To
The Member Secretary
Expert Appraisal Committee (2) in the Infrastructure Sector
Ministry of Environment and Forests & Climate Change
Indira Paryavaran Bhavan,
Jor Bagh Road, New Delhi - 110003
India.

Subject : Submission of compliance raised for Proposed EON IT Park at Sr.no 72/2/1, At
Kharadi, Taluka-Haveli, District Pune, State-Maharashtra by M/s EON Kharadi
Infrastructure Pvt. Ltd.

Ref : Minutes of the 12th Expert Appraisal Committee(Infra-2) for Item no 11.4.14
F. No. 21-73/2016-IA-III

Disposal Plan :

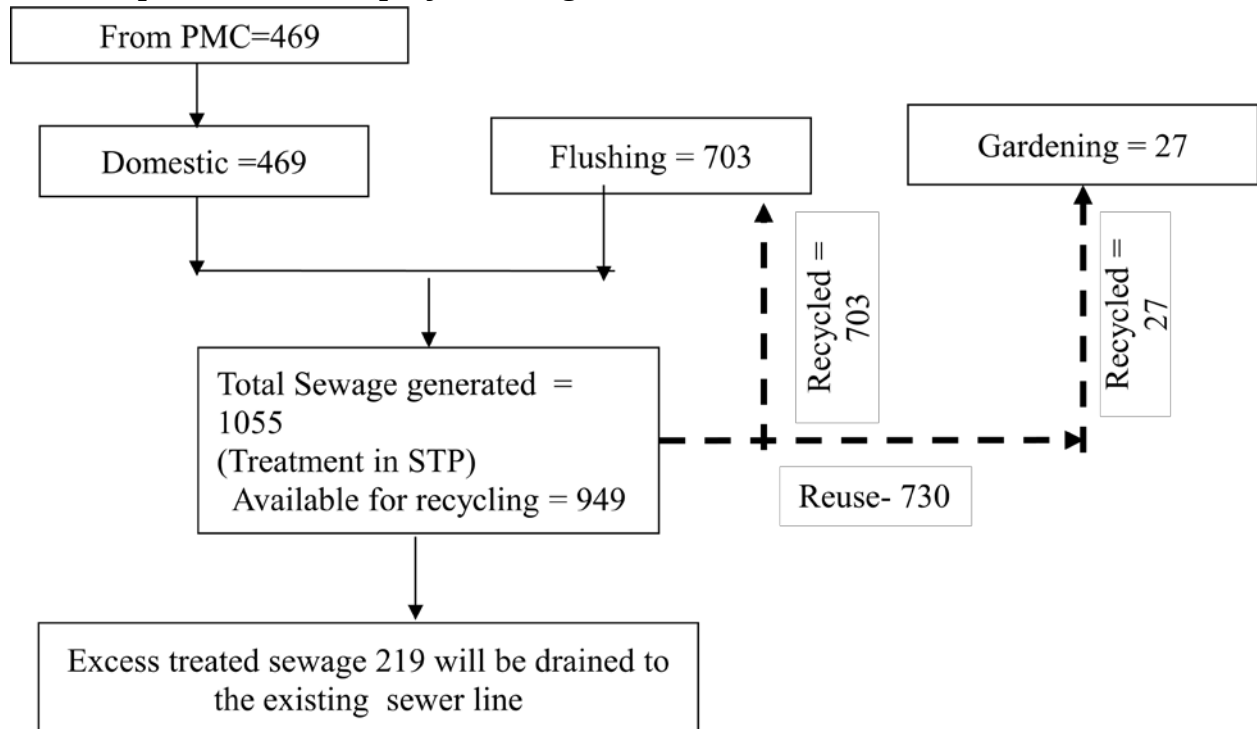
Excess treated sewage disposal plan/scheme to be submitted.

Figure 5-4 : Swept Path – Standard Fire Tender

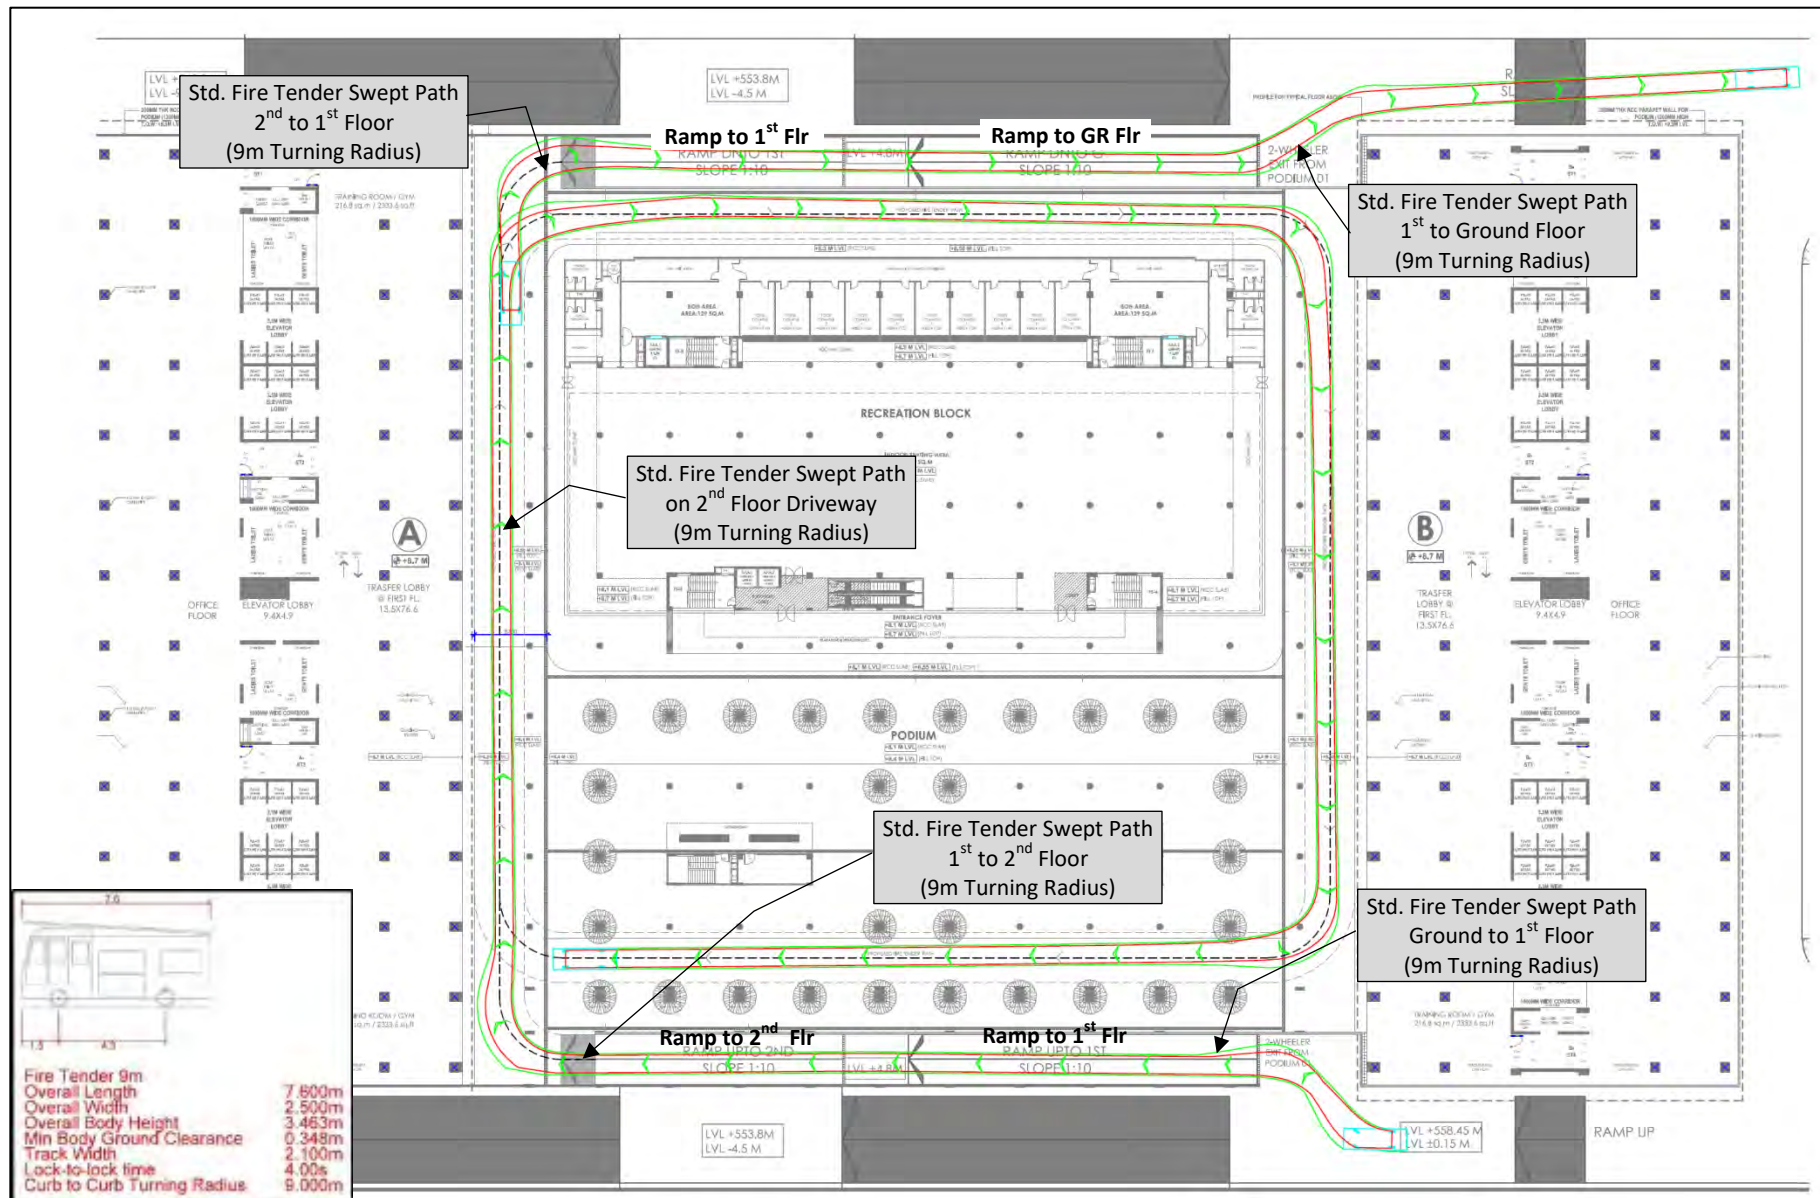
Layout plan indicating entry and exit points of vehicular movement as well as traffic management plan. Highlight the fire tender pathway.

- ✓ Sufficient turning space is available at entry and exit point from 30m access road for easy ingress of the fire tender to Ground Level.
- ✓ A standard fire tender can easily maneuver on Ground Floor driveway in one direction during emergency.
- ✓ Second floor is accessible for a Standard Fire Tender via proposed driveway on Ground floor (6m - 10m width) and 6m wide ramps.
- ✓ A standard Fire Tender can maneuver on the peripheral driveway provided on second floor in one direction during emergency.
- ✓ **Figure 5-4** is provided to show the swept path for the Standard Fire Engine movement.

SOLID WASTE MANAGEMENT FACILITY LAYOUT

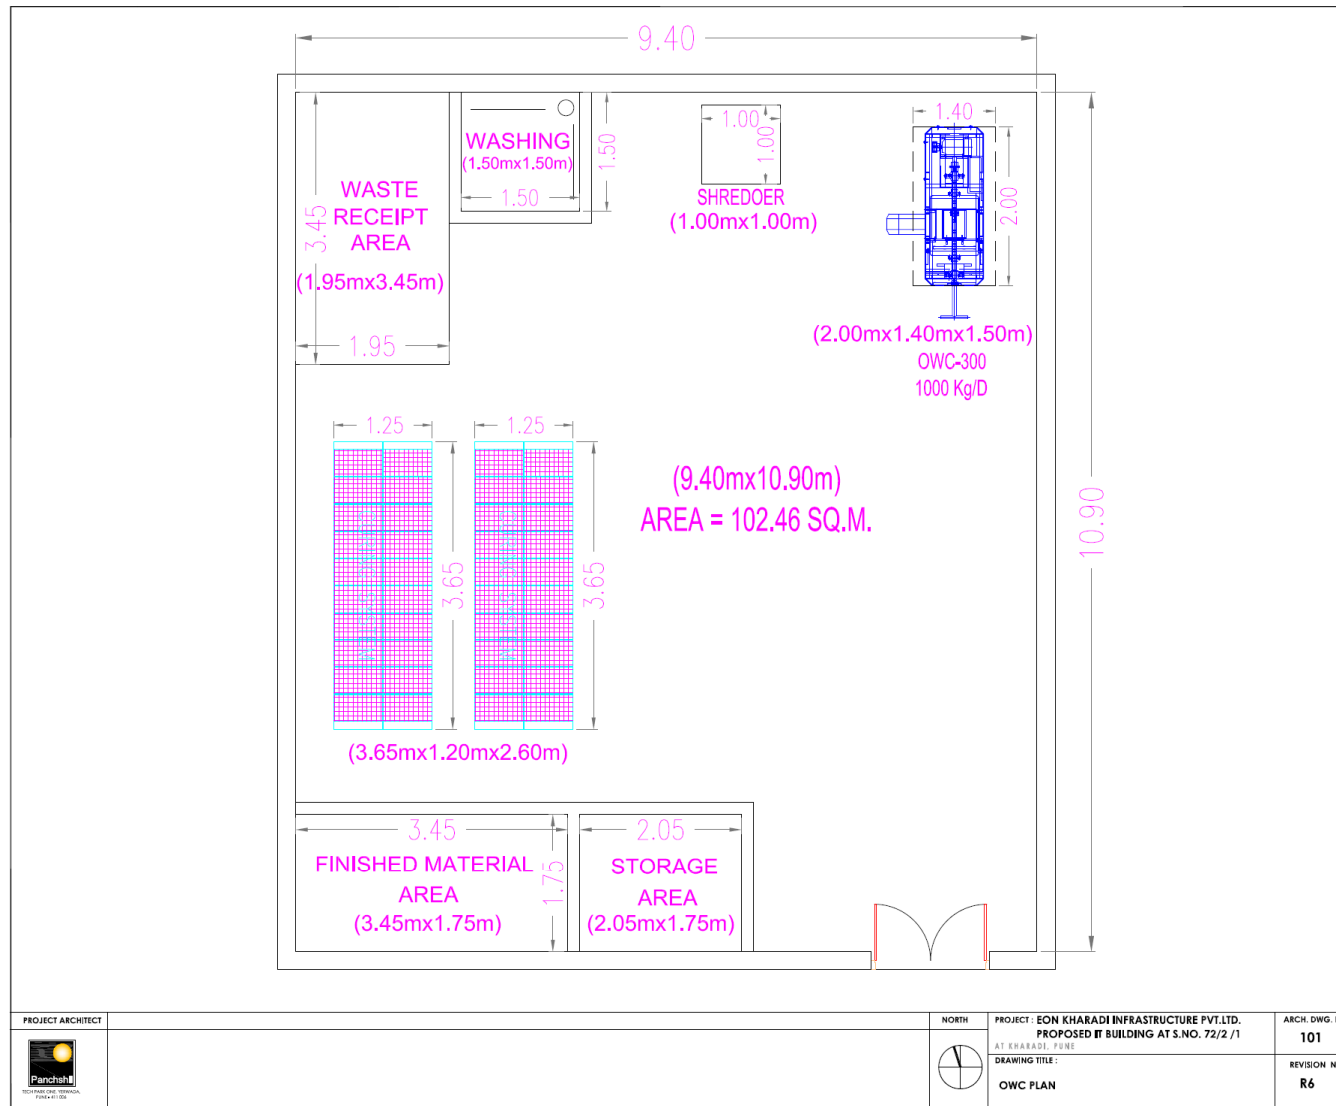
Solid waste management plan along with area earmarked for solid waste management scheme

Solid waste management plan is enclosed as **Enclosure -7**
